Form 3160-5
(June 2015)UNITED STATES
DEPARTMENT OF THE INTERIOR
BUREAU OF LAND MANAGEMENTFORM APPROVED
OMB No. 1004-0137
Expires: January 31, 2018**SUNDRY NOTICES AND REPORTS ON WELLS**
Do not use this form for proposals to drill or to re-enter an abandoned well. Use Form 3160-3 (APD) for such proposals.5. Lease Serial No. **NMMN-25478**

8. Well Name and No. **Cato San Andres Unit 200**9. API Well No. **30-005-20529**10. Field and Pool or Exploratory Area
San Andres4. Location of Well (Footage, Sec., T., R., M., or Survey Description)
0990' FSL & 0330' FEL Sec. 06 T09S R30E11. Country or Parish, State
Chaves

**Cato San Andres Unit 200
30-005-20529
BLM
June 2, 2023
Conditions of Approval**

PROPOSED			
Author:	Abby @ JMR		
Well Name	Cato San Andres Unit	Well No.	#200
Field/Pool	San Andres	API #:	30-005-20529
County	Chaves	Location:	990 FSL & 330 FEL
State	NM		Sec 6, T9S, R30E
Spud Date	2/20/1976	GL:	4125

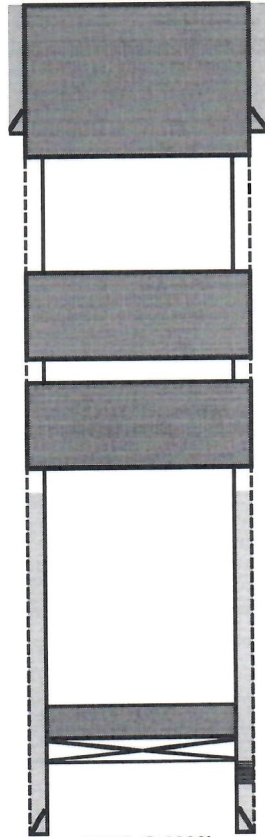
- 1. Operator shall place CIBP at 3,147' (50'-100' above top most perf) and place a minimum of 25 sx of Class C cement on top. WOC and TAG.**
- 2. Operator shall perf at 1,410' and squeeze Class C cement to 1,190' seal the Yates and bottom of the Salt Formation. WOC and TAG.**
- 3. Operator shall perf at 1,045' and squeeze Class C cement to 895' seal the top of the Salt Formation. WOC and TAG.**
- 4. Operator shall perf at 368' and squeeze class c cement to surface to seal the 8-5/8" casing shoe.**
- 5. Dry hole marker must be below ground.**
- 6. Surface reclamation will need to be completed once the well bore has been plugged. Please contact rflores@blm.gov for additional information.**
- 7. See Attached for general plugging stipulations.**

Plug #4: Perf & Sqz 167 sx class C cmt @ 368' & circulate to surface.
(138 sx outside, 29 sx inside)

Plug #3: Perf & Sqz 67 sx class C cmt w/ CaCl @ 1045-895'. WOC & tag (T/Salt)
(53 sx outside, 14 sx inside)

Plug #2: Perf & Sqz 96 sx class C cmt w/ CaCl @ 1,410-1,190'. WOC & Tag (Yates & B/Salt)
(77 sx outside, 19 sx inside)

Plug #1: Set 4 1/2" CIBP @ 3,147'. Spot 25 sx class C cmt w/ CaCl # 3,147-2,829'. WOC & Tag.
